ADDENDUM NO. 2

Rochester City School District

Dr. Walter Cooper, School #10

January 11th, 2019

AD2 - A1

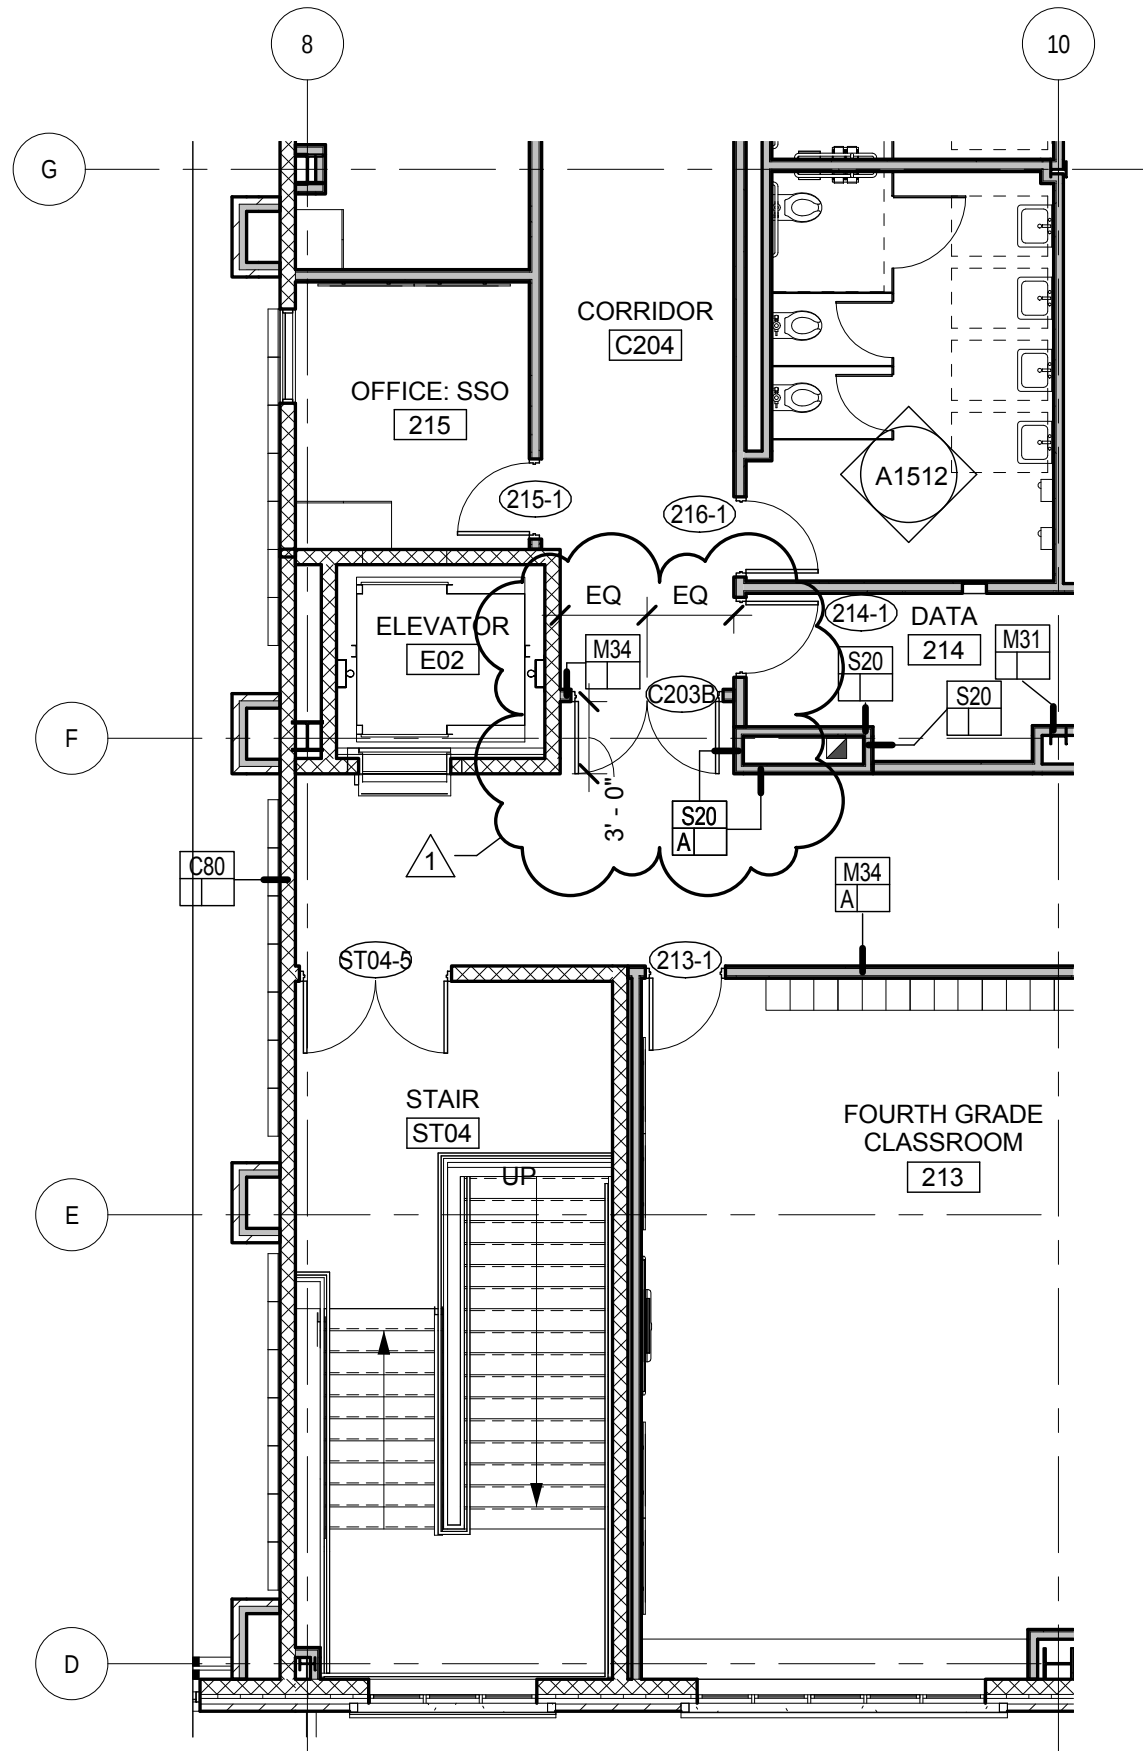
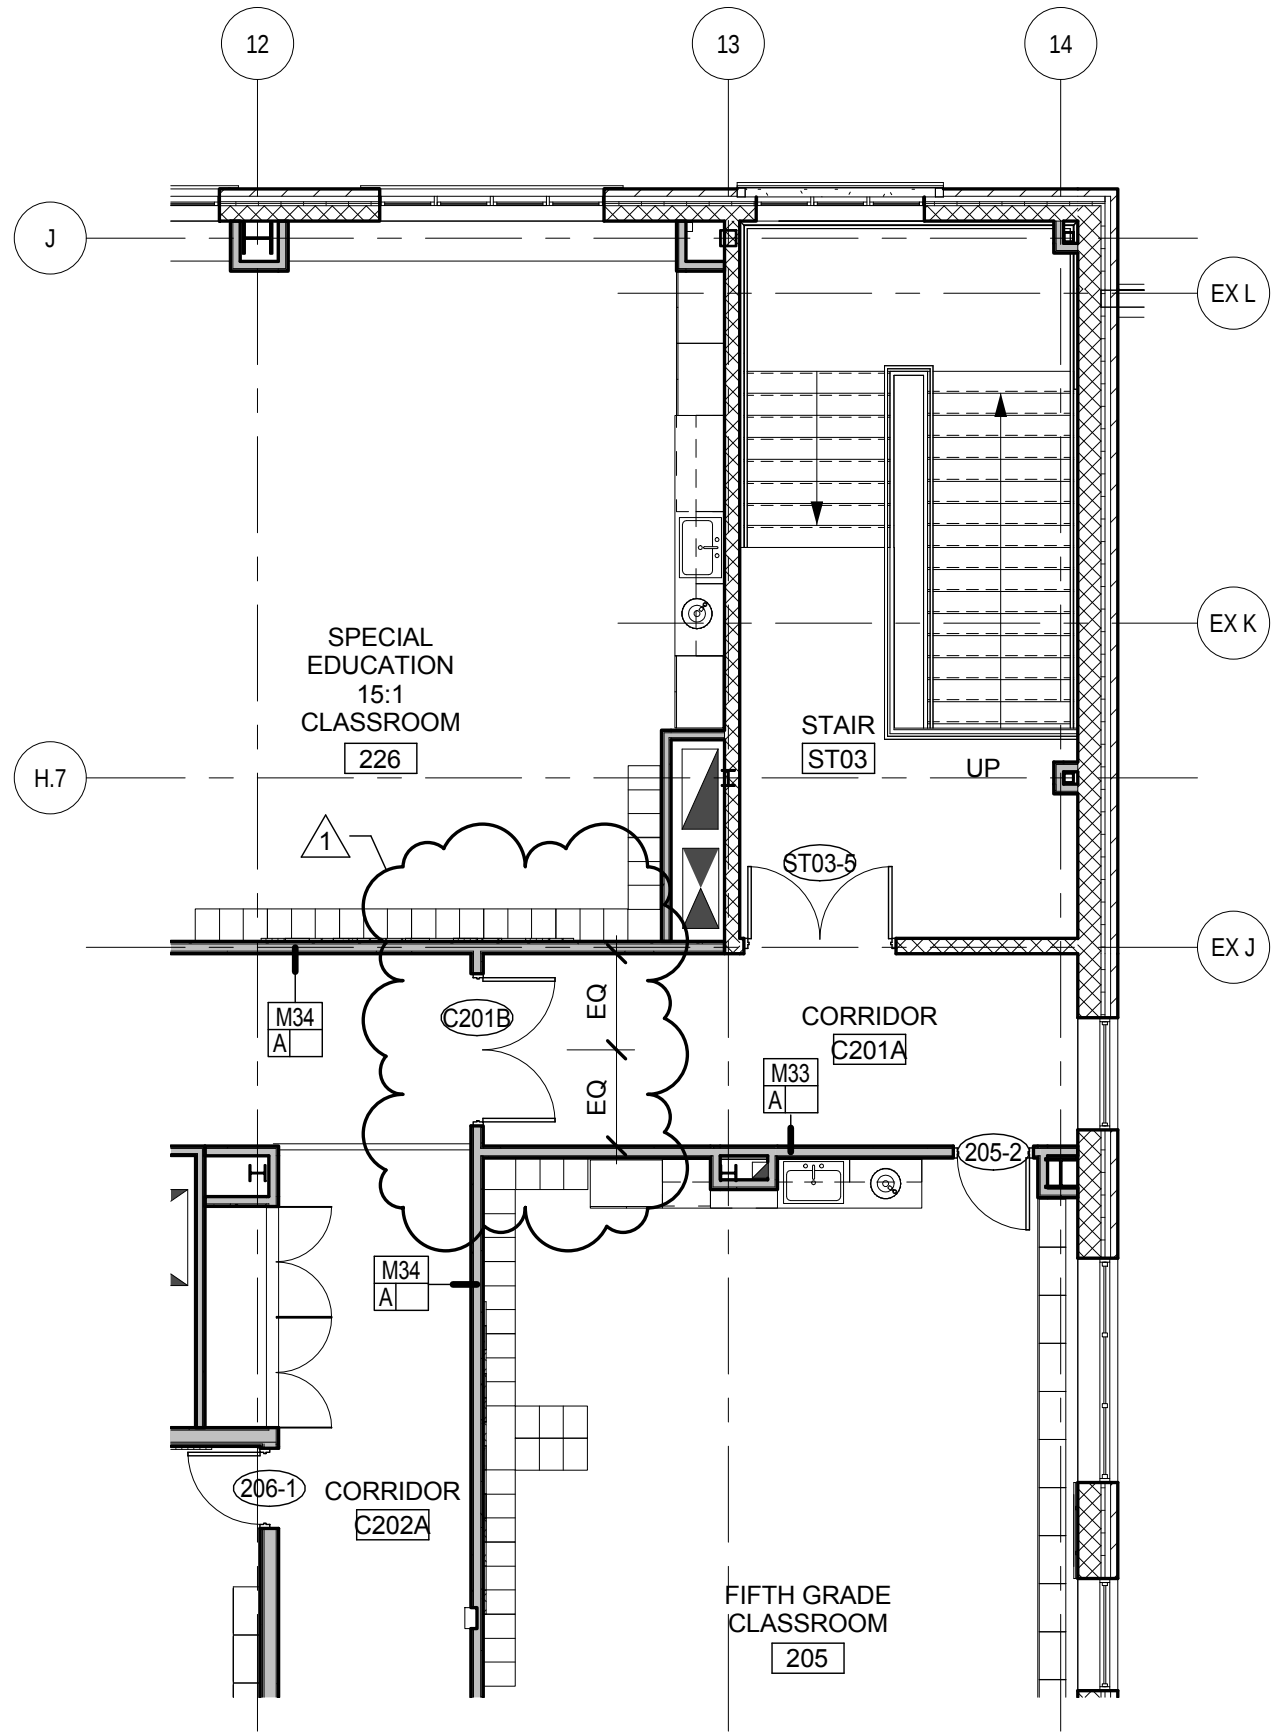
Item 2-16 **REVISE** Plan 1 SECOND FLOOR PLAN – AREA A as detailed on AD2-A1 PARTIAL SECOND FLOOR PLAN AREA A (dated 01/11/19).

Item 2-17 **REVISE** Plan 1 SECOND FLOOR PLAN – AREA as detailed on AD2-A4 PARTIAL SECOND FLOOR PLAN AREA A (dated 01/11/19).

GENERAL NOTE:
COORDINATE THE LOCATION OF EXIT SIGNS, AREA OF REFUGE SIGNS,
DOOR HOLD OPENS AND OTHER ELECTRICAL DEVICES WITH THE REVISED
LOCATION OF DOORS C201B AND C203B

2 PARTIAL SECOND FLOOR RCP
1/8" = 1'-0"

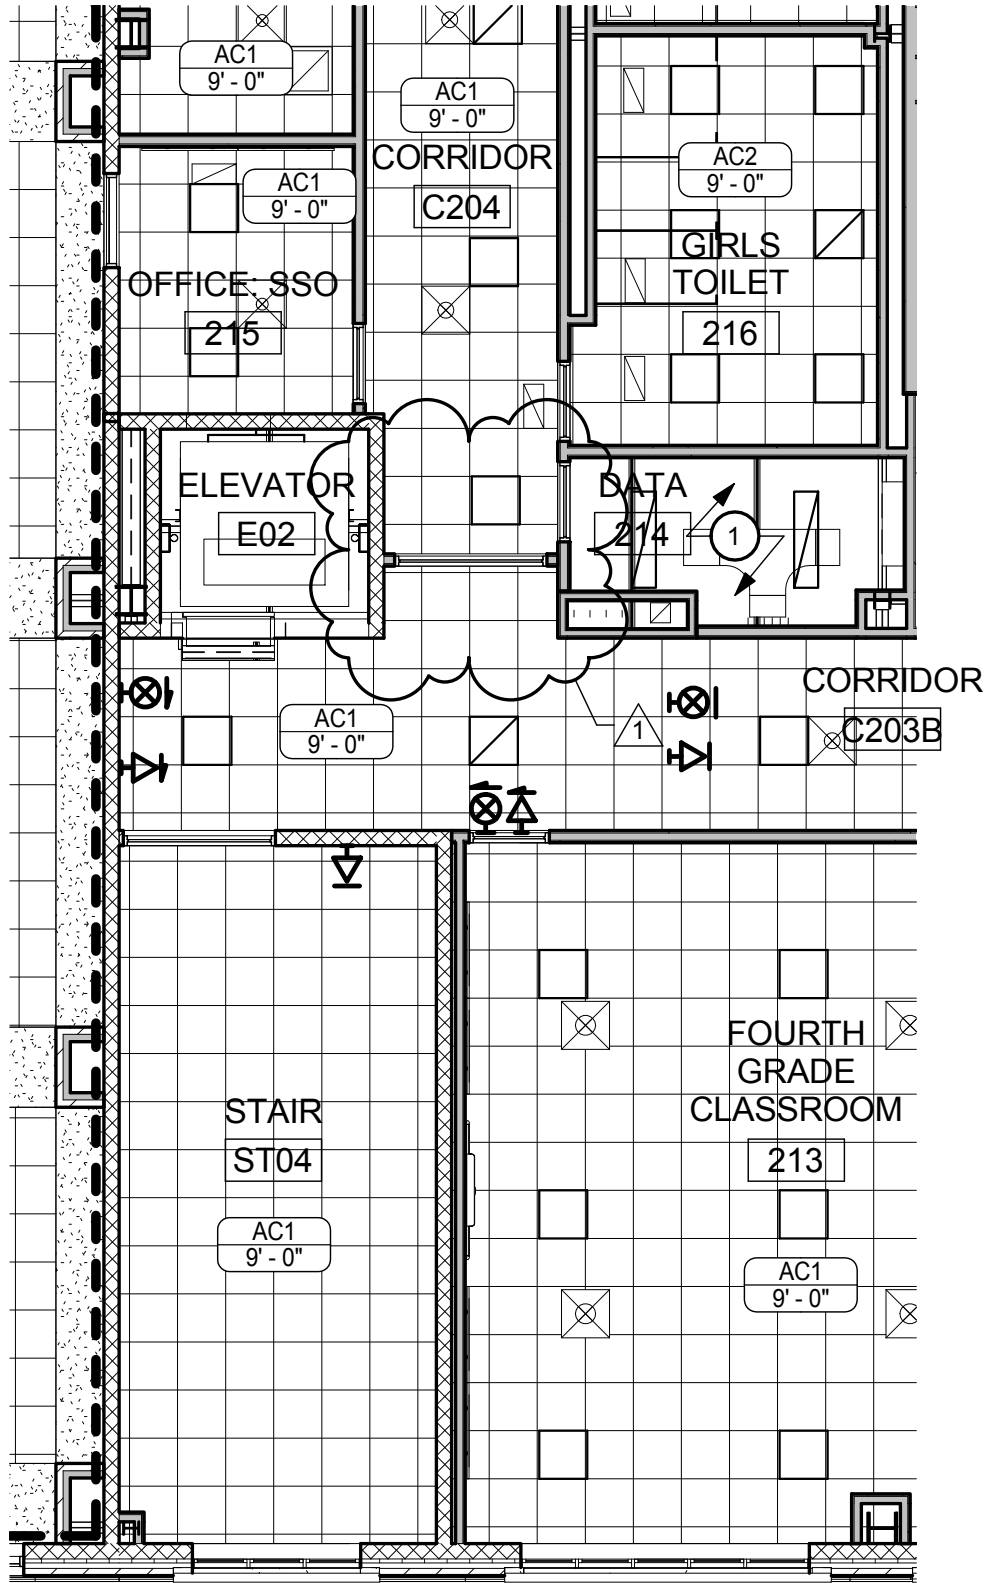
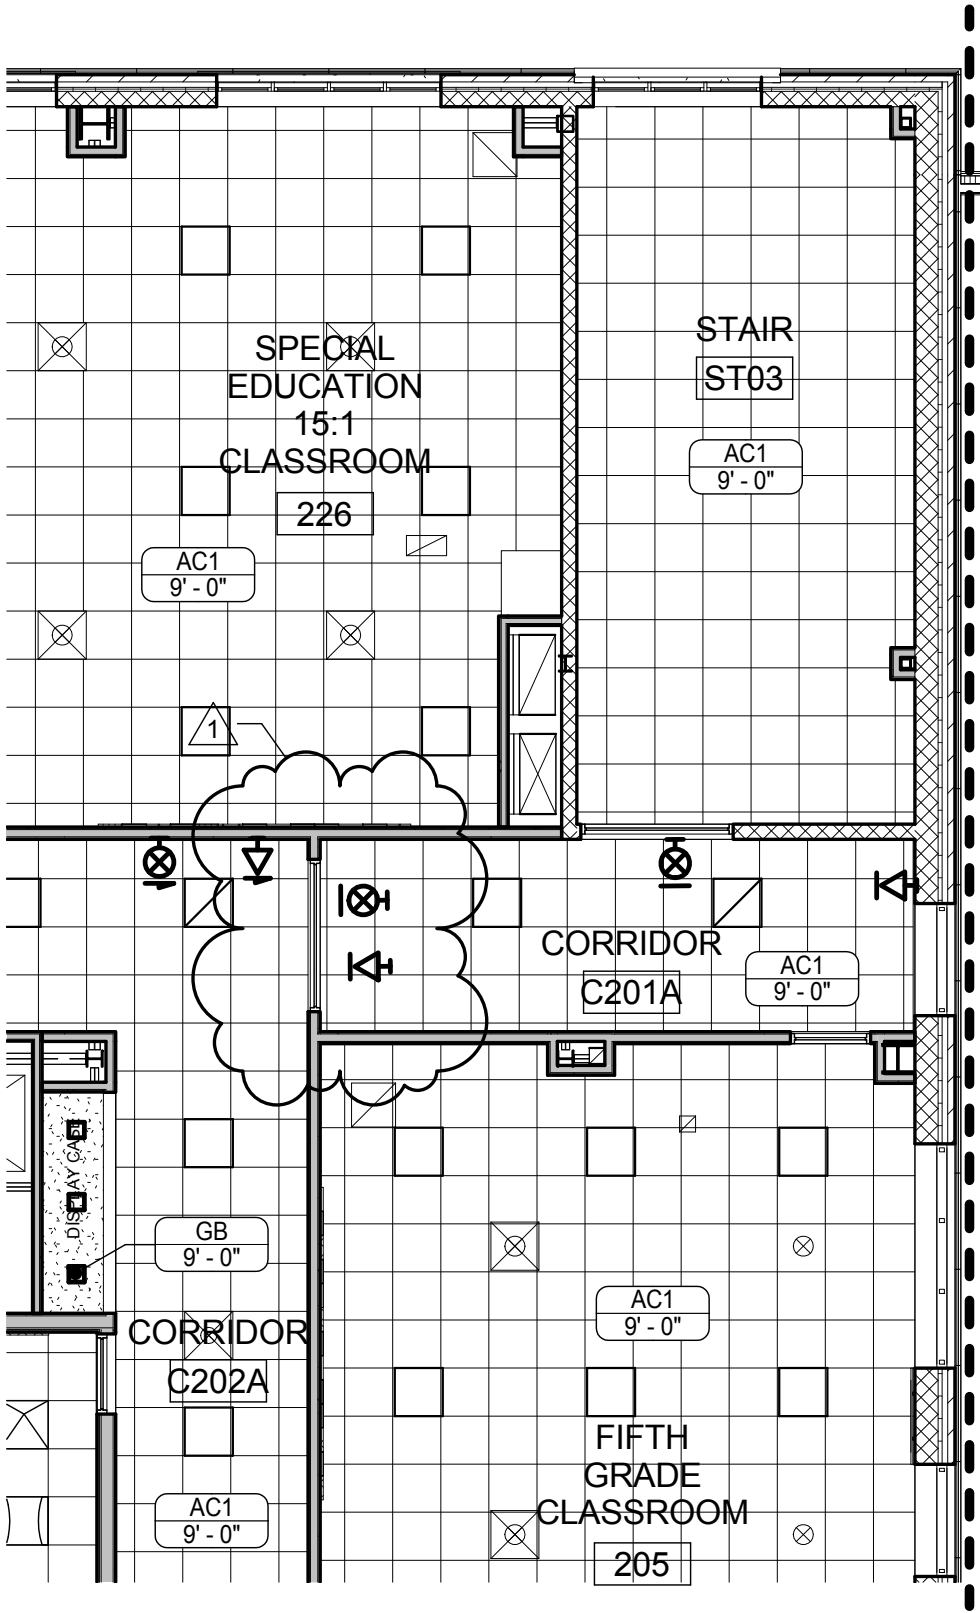
Item 2-18 **REVISE** Plan 1 PARTIAL SECOND FLOOR REFLECTED CEILING PLAN – AREA A as detailed on AD2-A2 PARTIAL SECOND FLOOR RCP AREA A (dated 01/11/19).

AD2 - A3

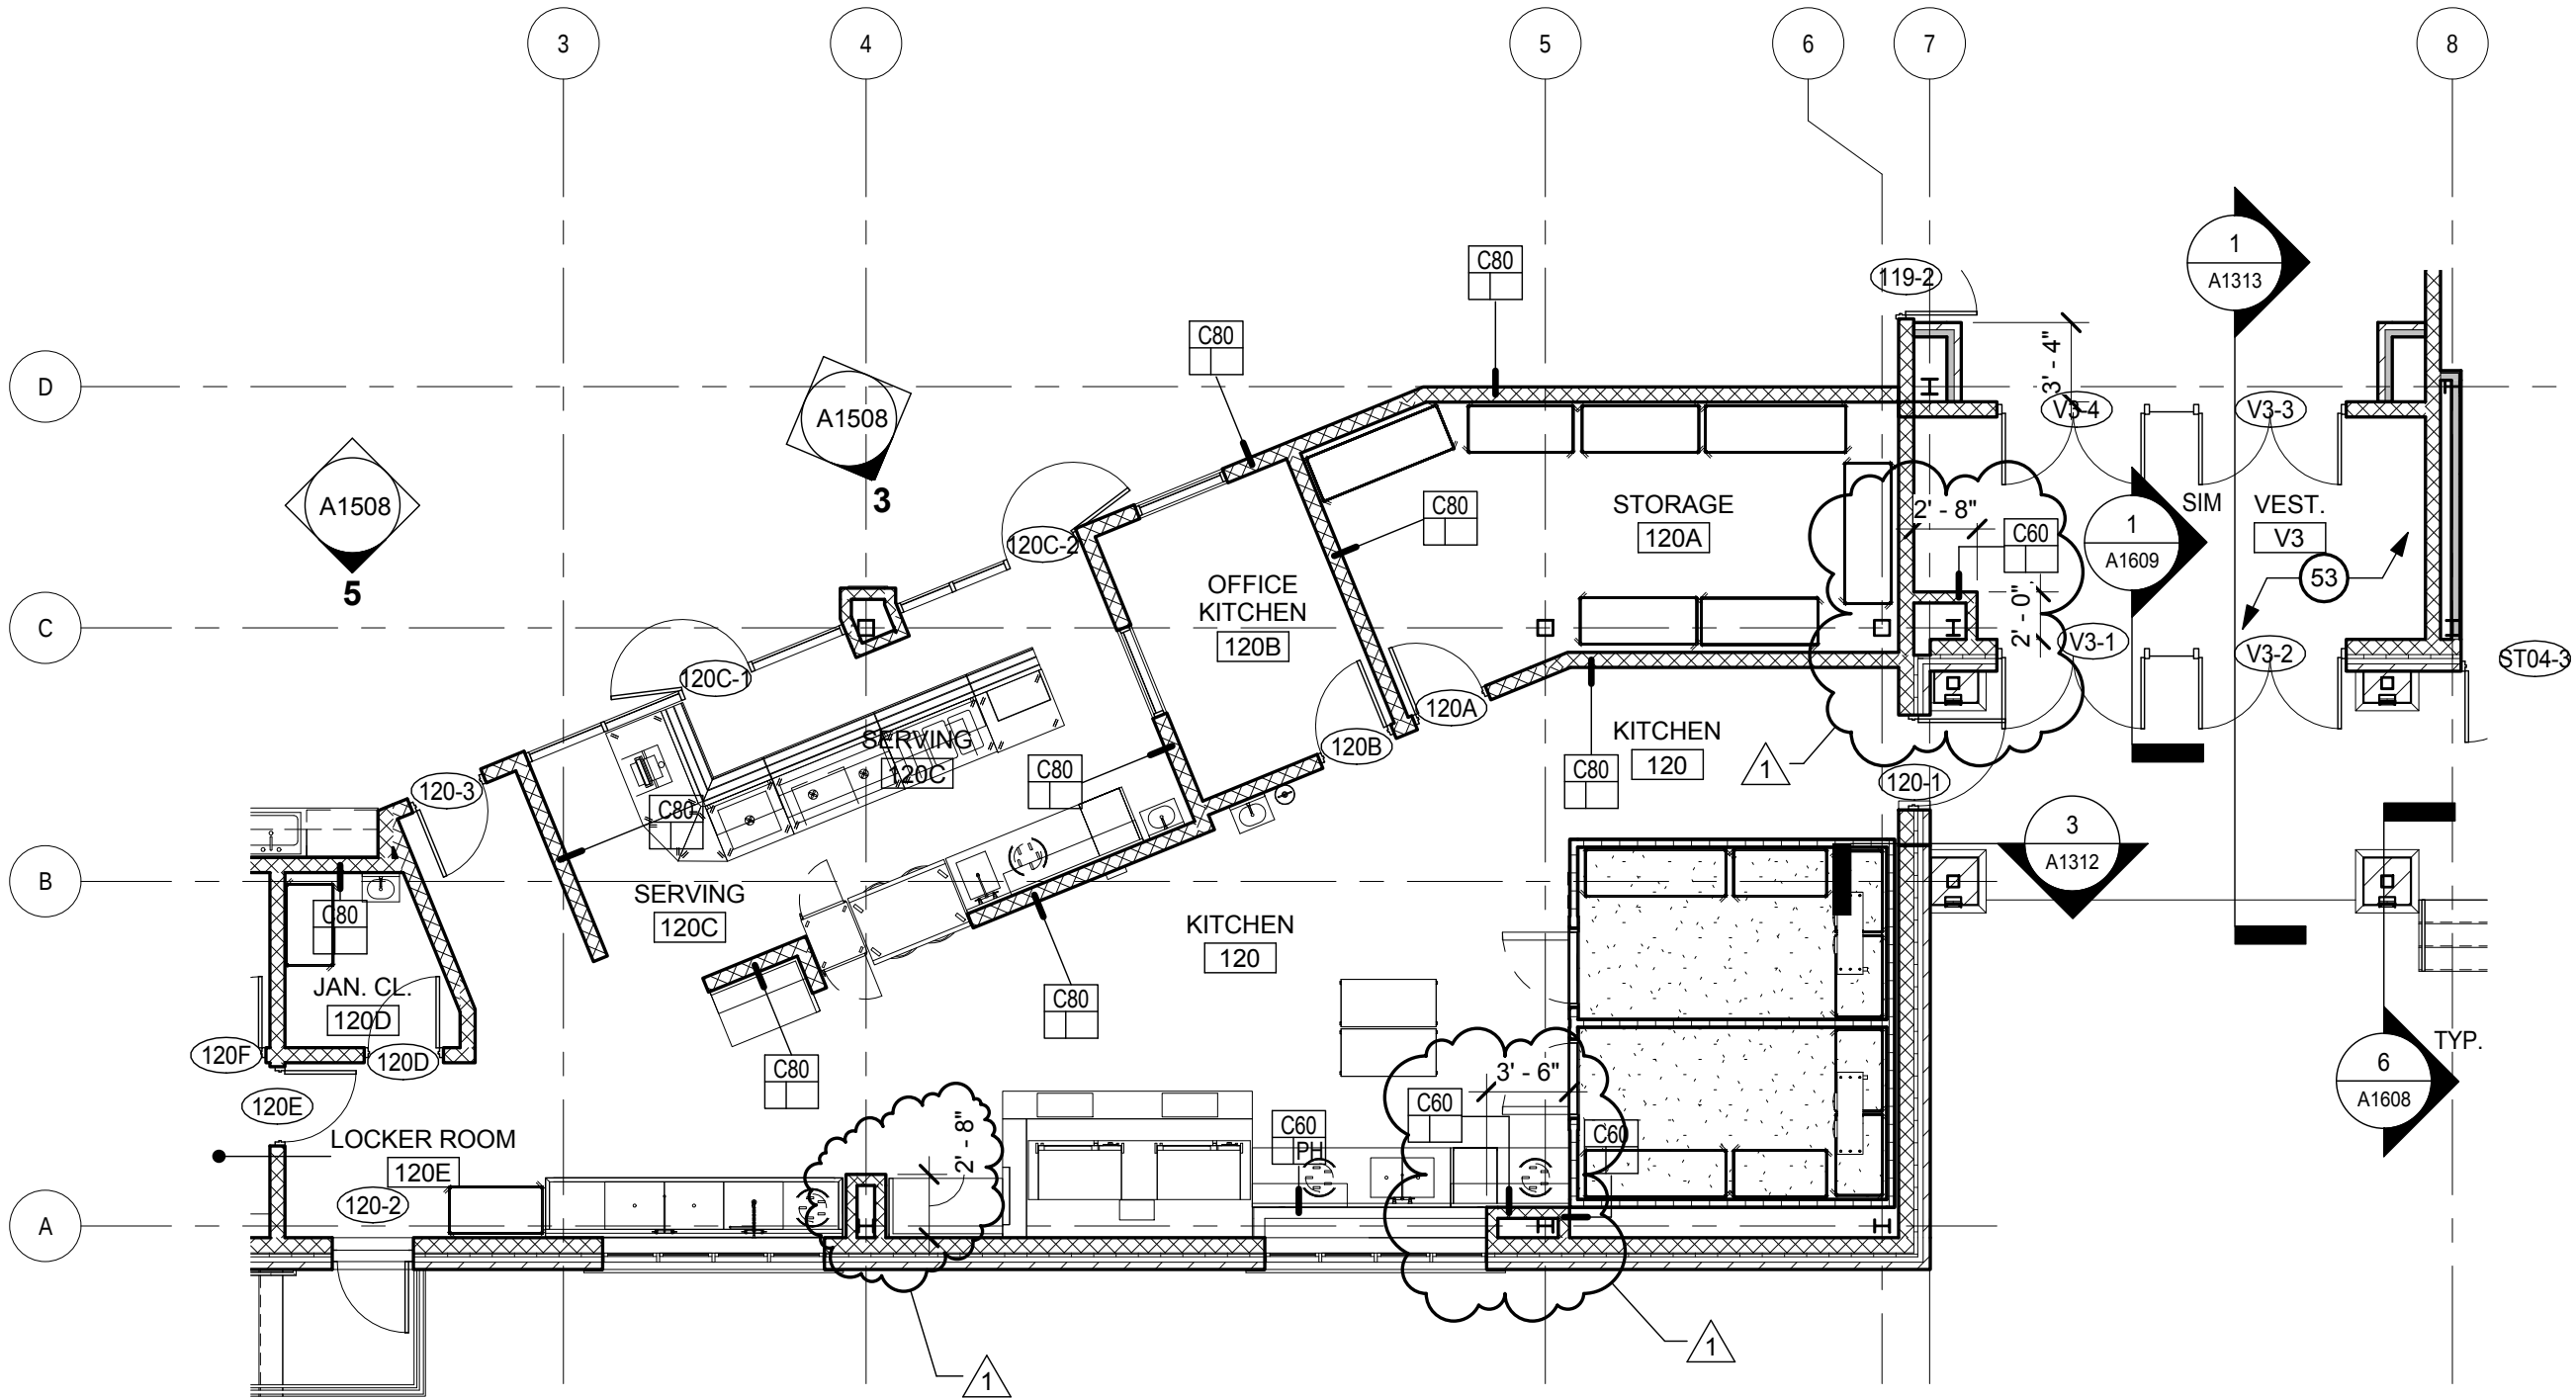
Item 2-15 **REVISE** Plan 1 FIRST FLOOR PLAN – AREA A as detailed on AD2-A3 PARTIAL FIRST FLOOR PLAN AREA A (dated 01/11/19).
